Access Compliance Report

Public Rights-of-Way

Intersection ID: 11450	Main Street: GRANDIN_RD	Cross Street: W MARTIN LUTHER KING JR BV	Location: N
ADA ID: 846A338D9D78	Ramp Type: Perp	Initial Pass/Fail: Fail	Overall Compliance: No
			Severity Score: 10

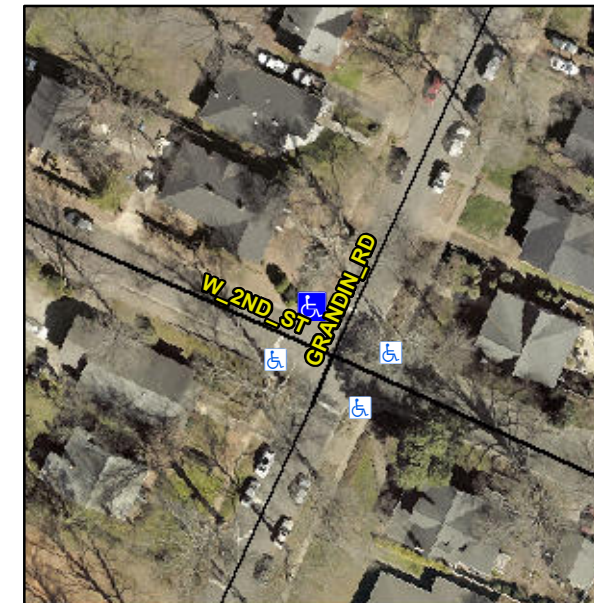
Not Found, R304.5.1, R304.5.3

Compliance	Description	Data	Compliance	Description	Data
N/A	Ramp Length (in)	77.0	Yes	Ramp Slope (%)	7.9
No	Ramp Width (in)	44.0	No	Ramp XSlope (%)	2.6
N/A	Flare Type LT	N/A	N/A	Flare Type RT	N/A
N/A	Flare Slope LT (%)	N/A	N/A	Flare Slope RT (%)	N/A
N/A	Flare Traversable LT?	N/A	N/A	Flare Traversable RT?	N/A
N/A	Landing Length (in)	N/A	N/A	DWS Provided?	N/A
N/A	Landing Width (in)	N/A	N/A	DWS Contrast?	N/A
N/A	Landing Slope (%)	N/A	N/A	DWS Length (in)	N/A
N/A	Landing X Slope (%)	N/A	N/A	DWS Full Width?	N/A
N/A	Landing Curb? (Y/N)	N/A	N/A	DWS Offset (in)	N/A
N/A	Shared Landing?	N/A			
N/A	Gutter Ponding?	N/A	N/A	Gutter Slope (%)	N/A
N/A	Gutter Lip Ht (in)	N/A	N/A	Gutter X Slope (%)	N/A
N/A	Painted X Walk1?	No	N/A	Painted X Walk2?	N/A
	X Walk 1 Direction	To S		X Walk 2 Direction	N/A
N/A	X Walk 1 Width (in)	N/A	N/A	X Walk 2 Width (in)	N/A
	X Walk 1 Slope (%)	3.0		X Walk 2 Slope (%)	N/A
	X Walk 1 X Slope (%)	2.4		X Walk 2 X Slope (%)	N/A

Remove & Replace Entire Ramp.
